Final Drainage Report
for
WindingWalk Filing 2
at
Meridian Ranch

EL PASO COUNTY, COLORADO

July 2018

SF-18-022

INDEX MAP
N.T.S.

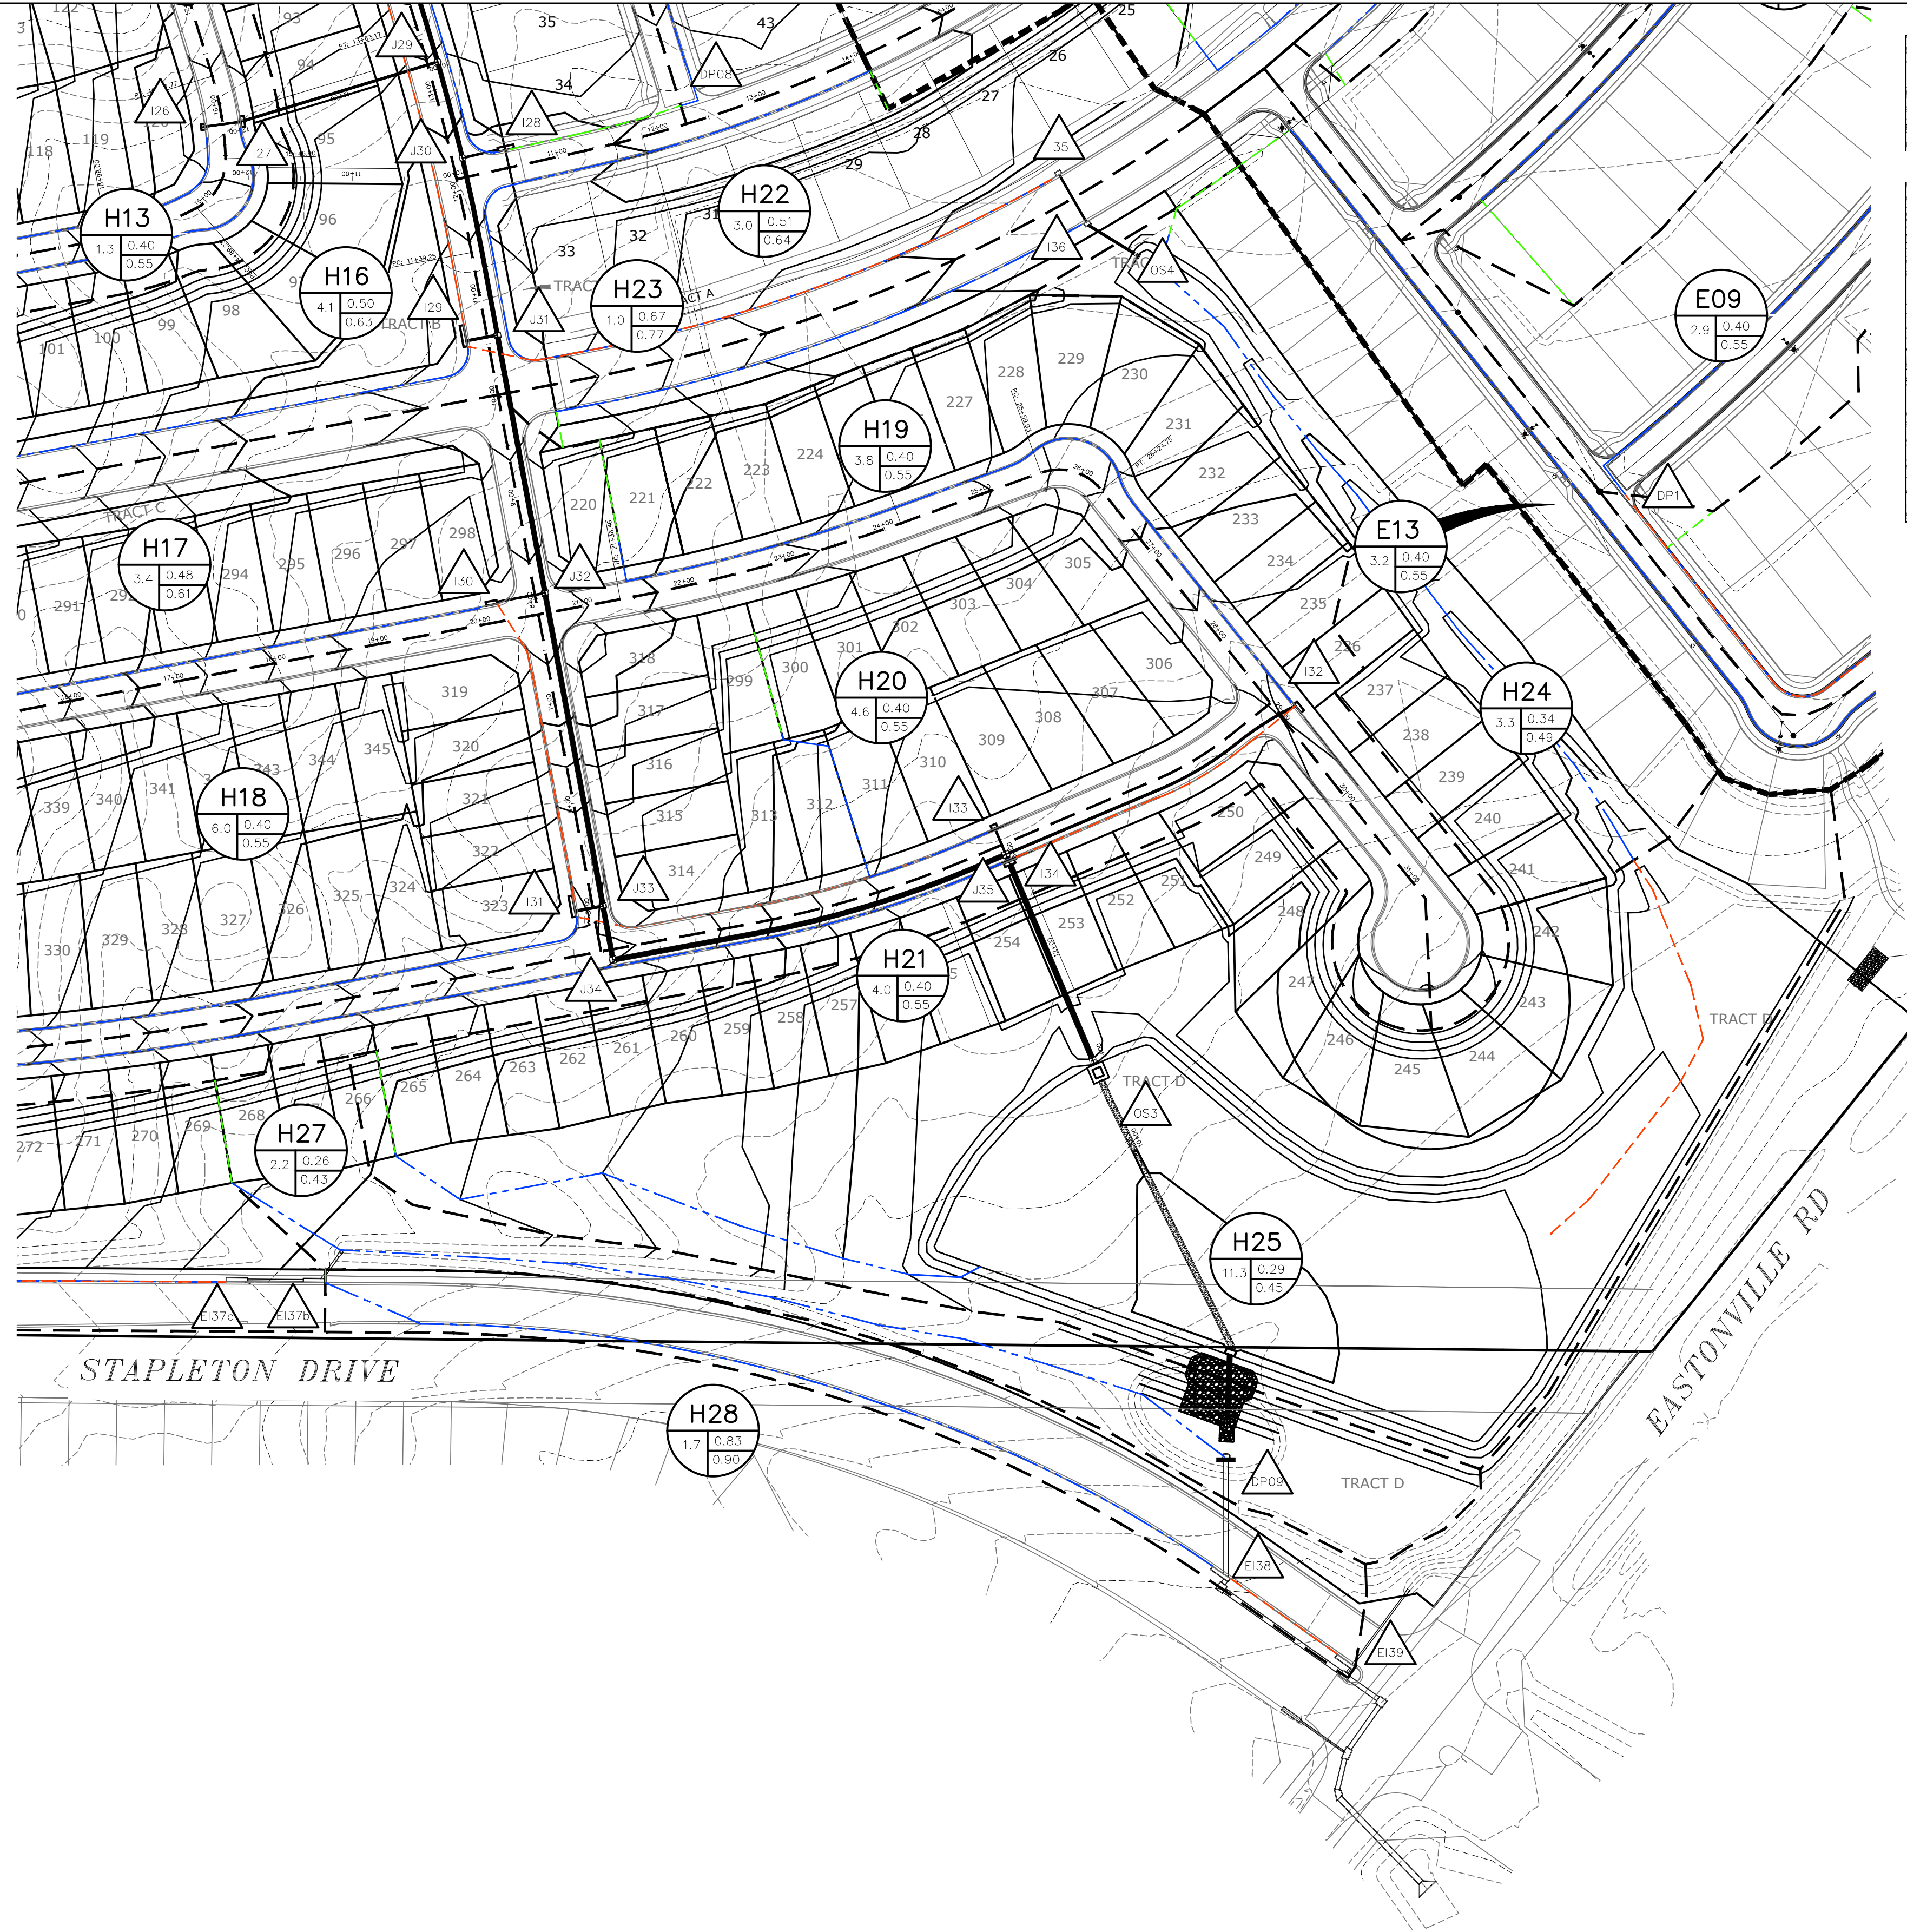
Update the rational drainage map and calculations to specifically be for winding walk filing 2. You can add text box identifying the surrounding subdivision filing or highlight the subject area. The majority of the subbasins in sheets 1 & 3 are for a different subbasin.
Main takeaway is that the project area should be readily discernible.
